SCOPING REPORTS AND EMAILS

LAND AT WESTERGATE

Transport Assessment Scoping Note

Figure 3-2 - Junction Capacity Assessment Scope

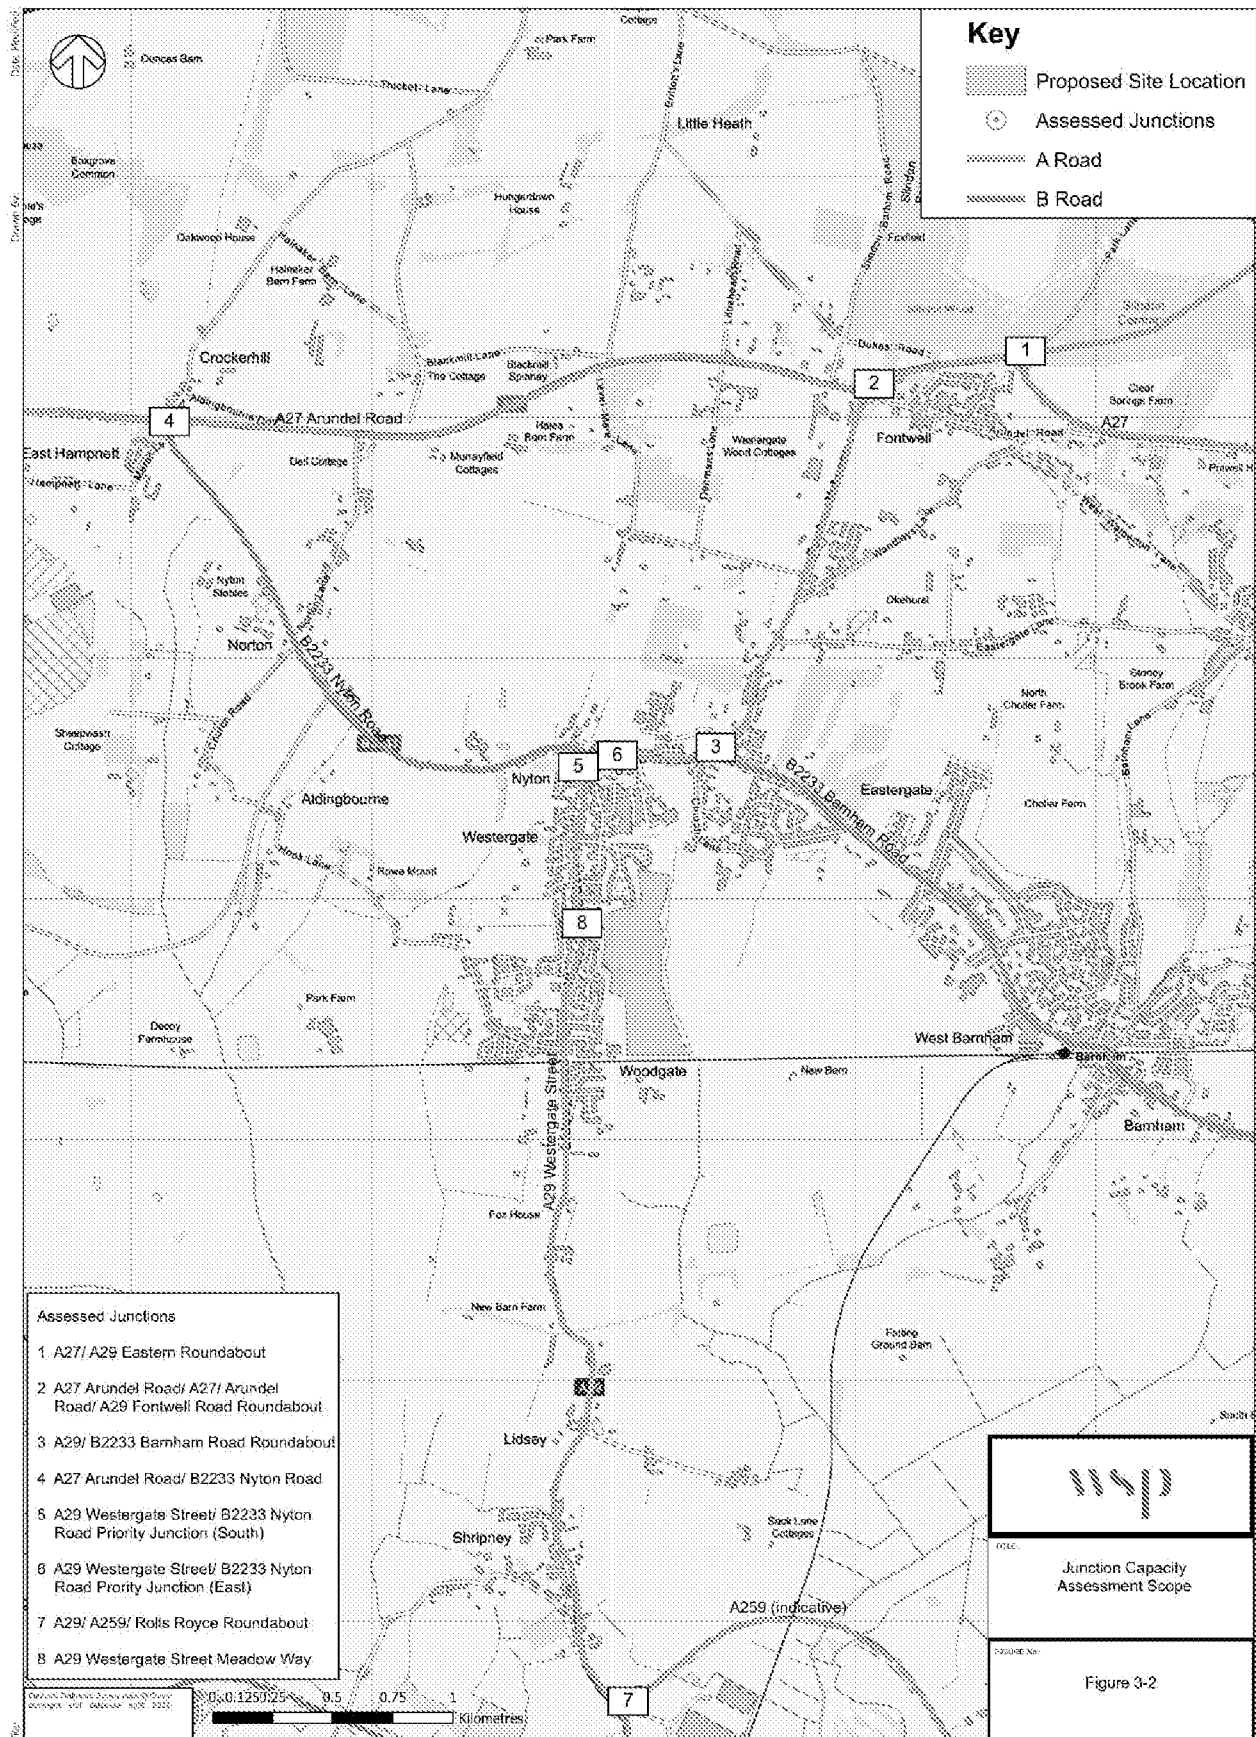
10. *Figure 3-2* – The assessed junctions may need to be expanded given additional homes proposed and given mention of 4300 homes for the overall allocation.

DRAWING No: 3258/GA/004

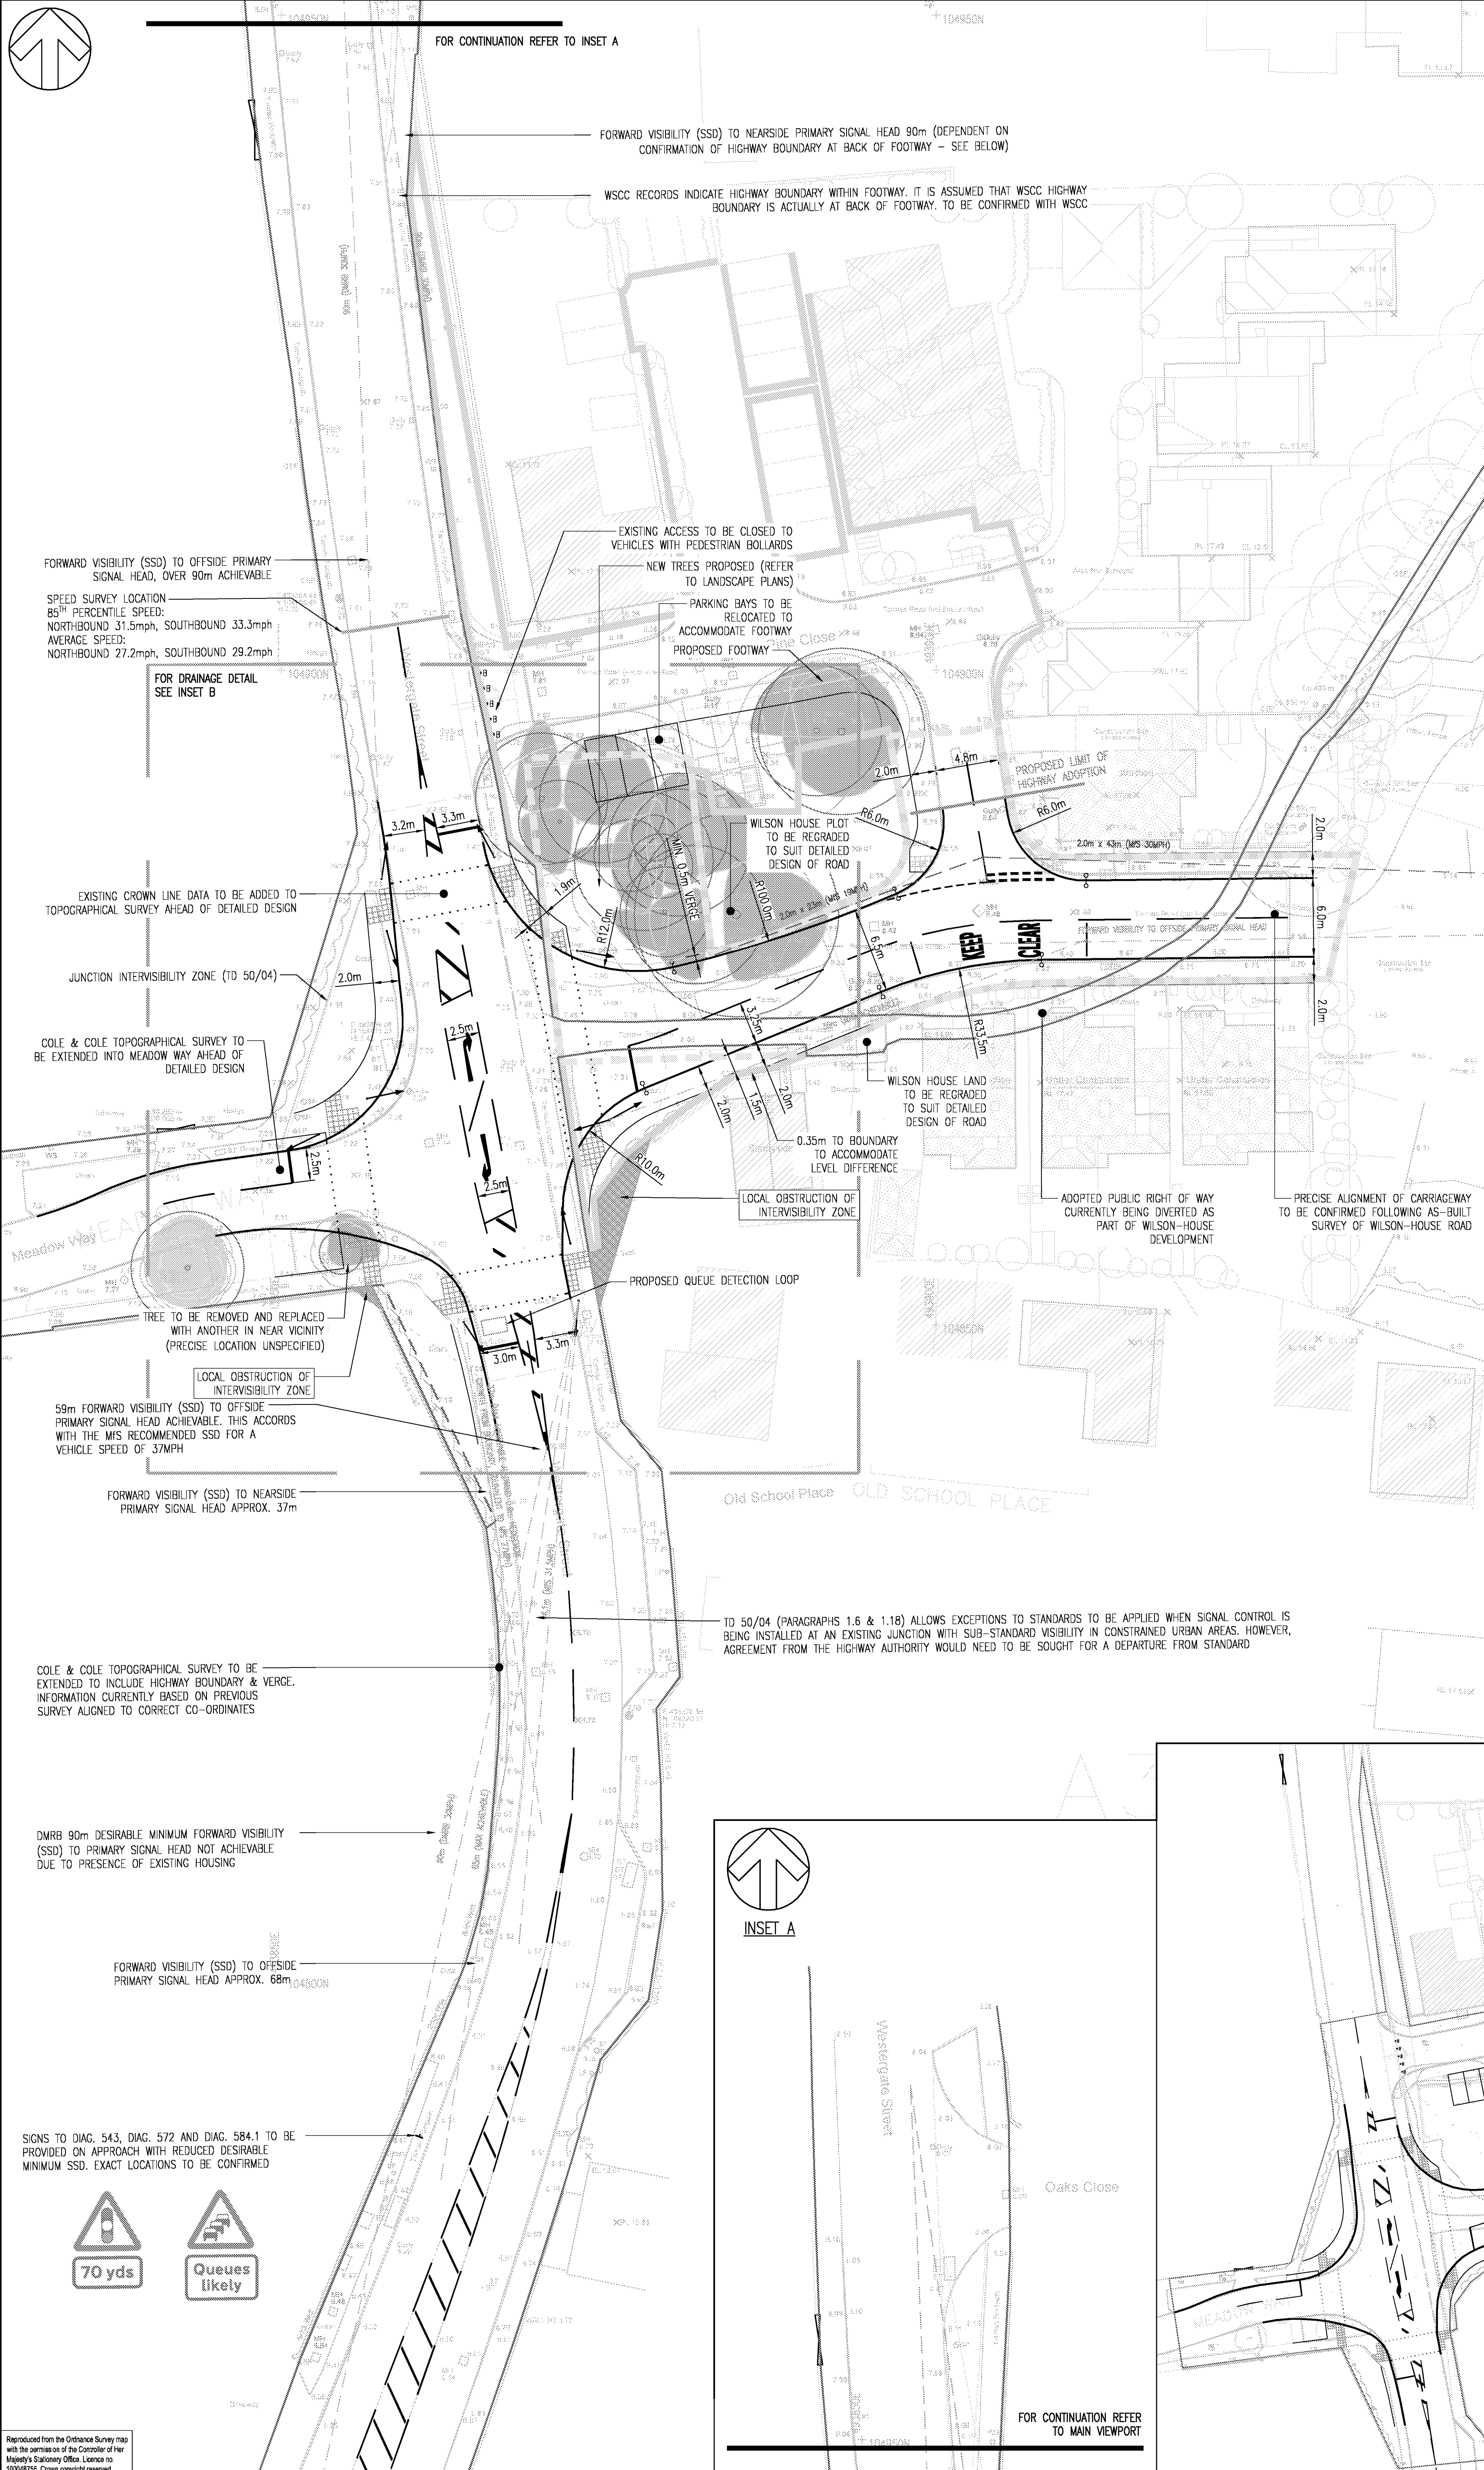
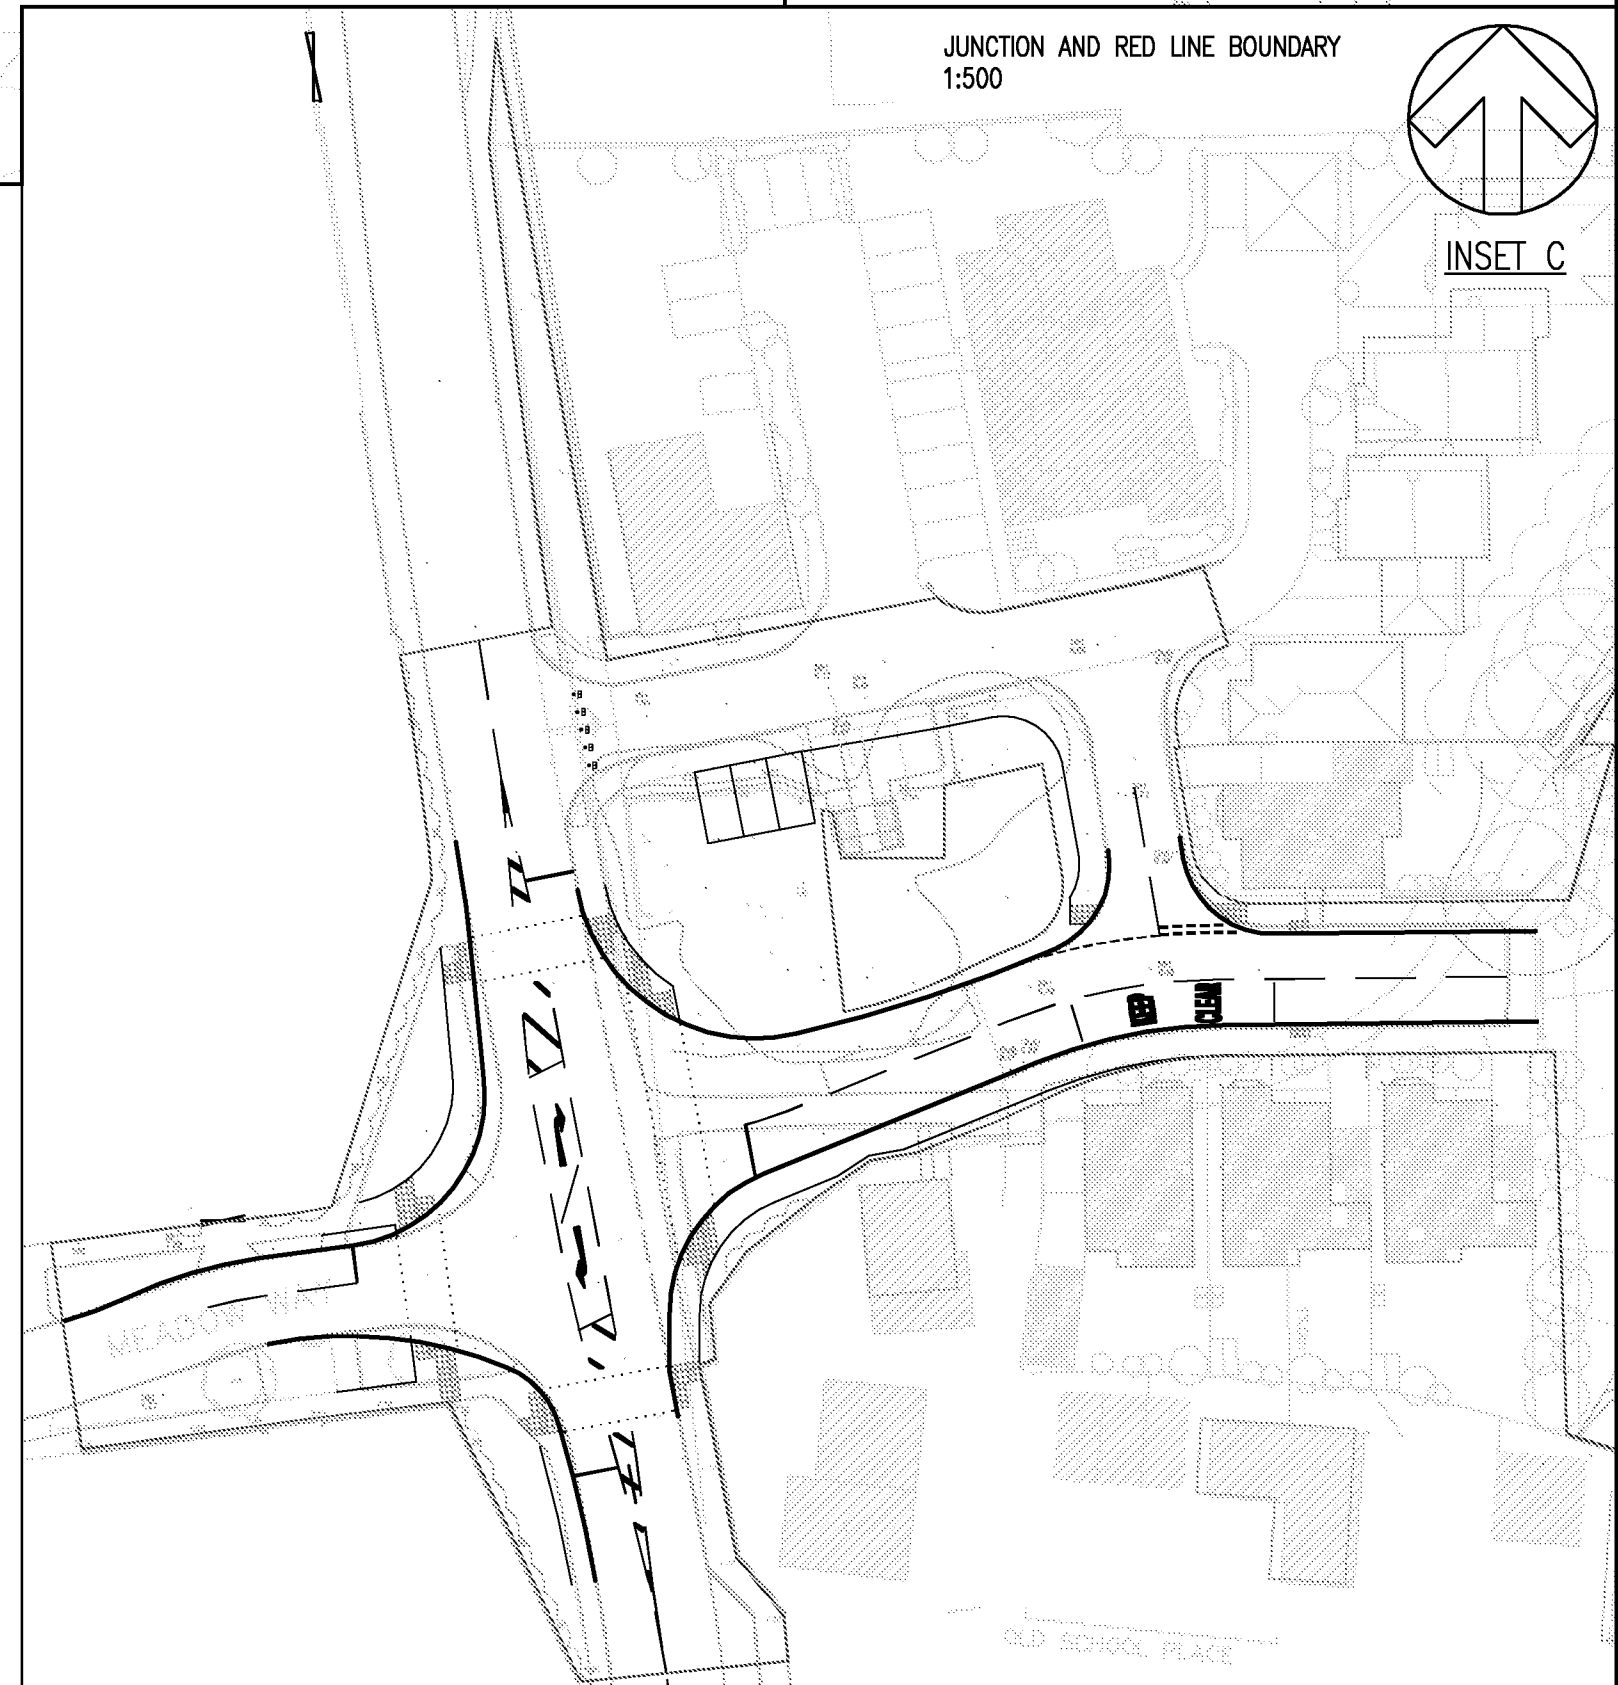
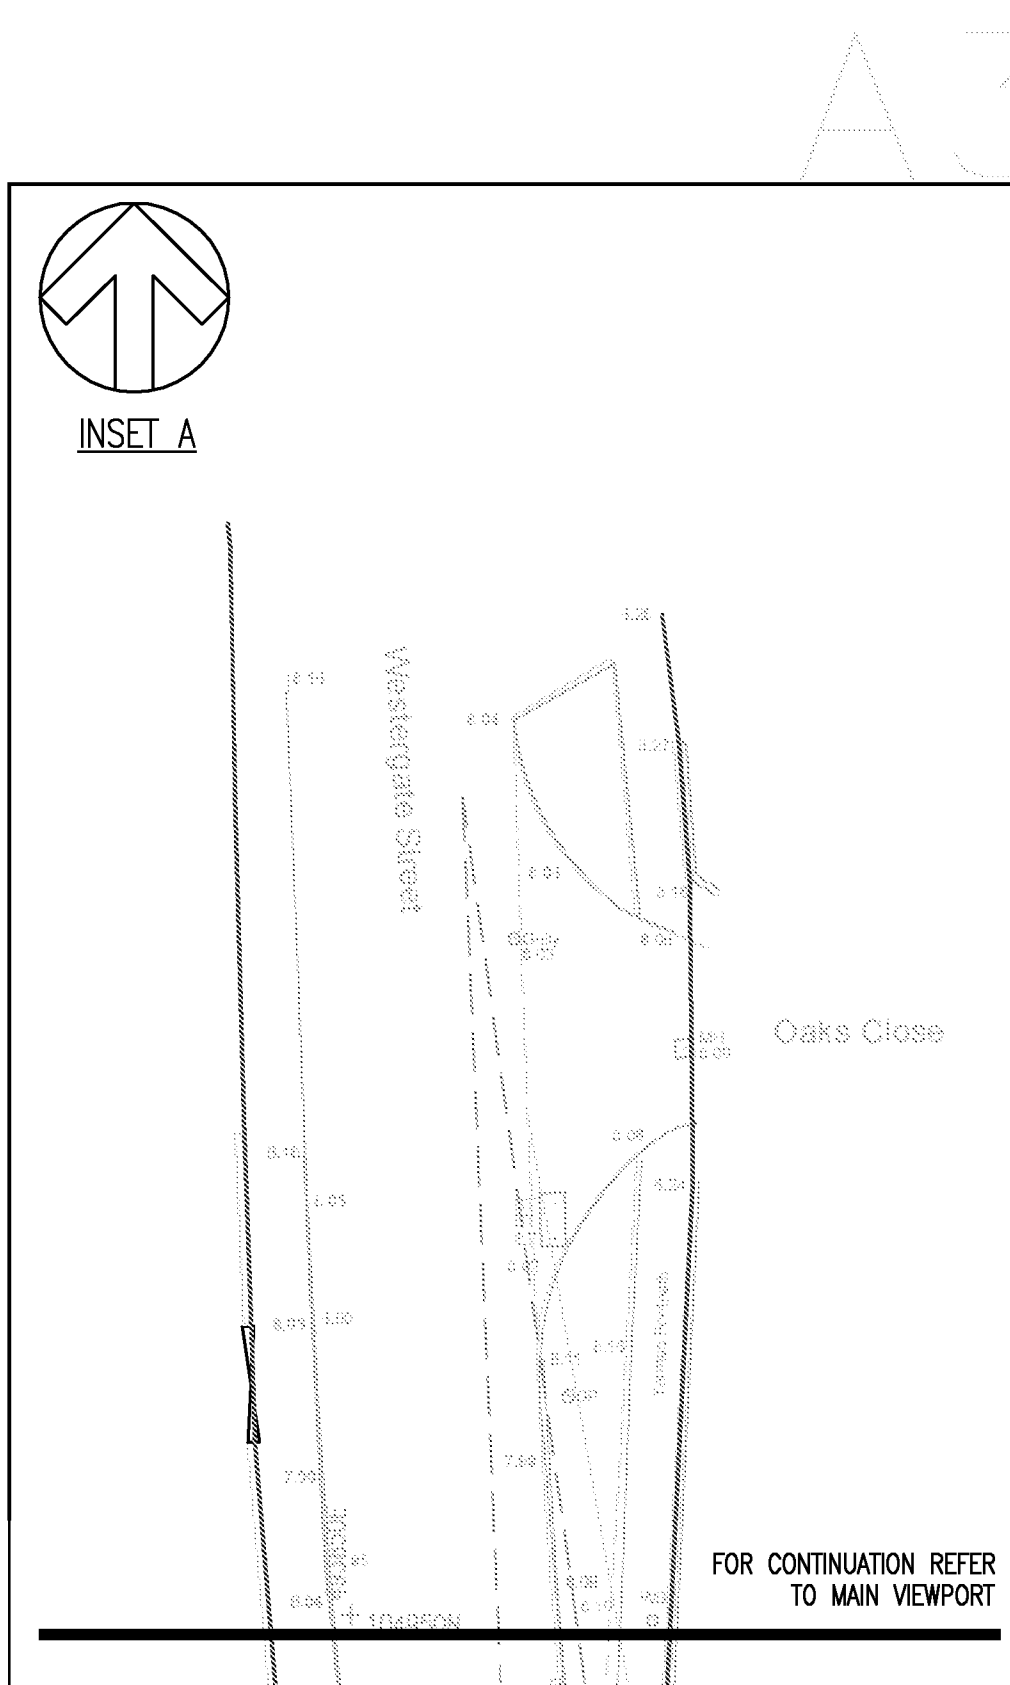
3.3.1 **PROBLEM** *(Drawing ref: 3258/GA/004 Rev C & /ATR/003 Rev B)*

The proposed junction design may need to be revisited with a view to investigating scope for shifting the northbound stop line and corresponding signal poles a few more metres further southwards of the currently shown position, which may also provide safer scope for large vehicles turning sharp left manoeuvre from the new site access road. A high level off-side secondary signal head may also need to be included.

3.5.1 **PROBLEM** *(Drawing ref: 3258/GA/004 Rev C)*

REF.	COMMENT	DESIGNERS RESPONSE
3.3.1	Location: (A) A29 Westergate Street, south of the junction with Meadow Way and the new access road. Summary: Risk of inadequate forward visibility of stop-line for waiting vehicles and/ or waiting pedestrians. Recommendation: The proposed junction design may need to be revisited with a view to investigating scope for shifting the northbound stop line and corresponding signal poles a few more metres further southwards of the currently shown position which may also provide safer scope for large vehicles turning sharp left manoeuvre from the new site access road. A high level off-side secondary signal head may also need to be included. The yellow box markings indicated for the southbound traffic flow may also need to be extended to also include the northbound through flows. It is further recommended that high friction surfacing should also be incorporated on the northbound approach for sufficient length to mitigate the potential northbound vehicle queuing and risk of failure to perceive the red lights associated with the signalised junction and pedestrian crossing facility.	<i>It has not been possible to relocate the A29 northbound stop-line further southwards due to the need to maintain junction inter-visibility between stop-lines. While full inter-visibility as measured in DMRB is not possible the current arrangement allows visibility between the A29 northbound and site access stop-line, which includes the extent of access road pedestrian crossing. Moving the A29 northbound stop-line further south would remove visibility between stop-lines.</i> <i>The ability to relocate the northbound stop-line further south is also limited by the residential property located on the south eastern corner of the junction, whereby such a modification would obstruct the visibility between the A29 northbound and site access road stop-line.</i> <i>The option of relocating the access road stop-line slightly westwards (to extend the limits of the junction inter-visibility further southwards on the A29 northbound) has been explored but this is not possible due to proximity of the pedestrian crossing on the access road to the A29 southbound lane.</i> <i>High friction surfacing will be incorporated into detailed design stages of the proposed junction.</i>

REF.	COMMENT	DESIGNERS RESPONSE
3.5.1	Location: (B) A29 Westergate Street, at the approaches to the new signalised junction. Summary: Risk of failure to perceive new junction control ahead. Recommendation: The proposed signing works should also include appropriate temporary warning signs to TSRGD Diagram 7014 for a slightly longer period of say six months to alert visiting drivers to the new signalised junction.	<i>It is agreed that temporary warning signs should be erected but timescales will need to be agreed with WSCC as part of the technical approval process.</i> <i>The junction design also includes provision of signage to Diagrams 543, 572, 584.1 of TSRGD to warn drivers on the A29 northbound of the traffic signal junction. This should help non-local drivers identify the junction ahead.</i>
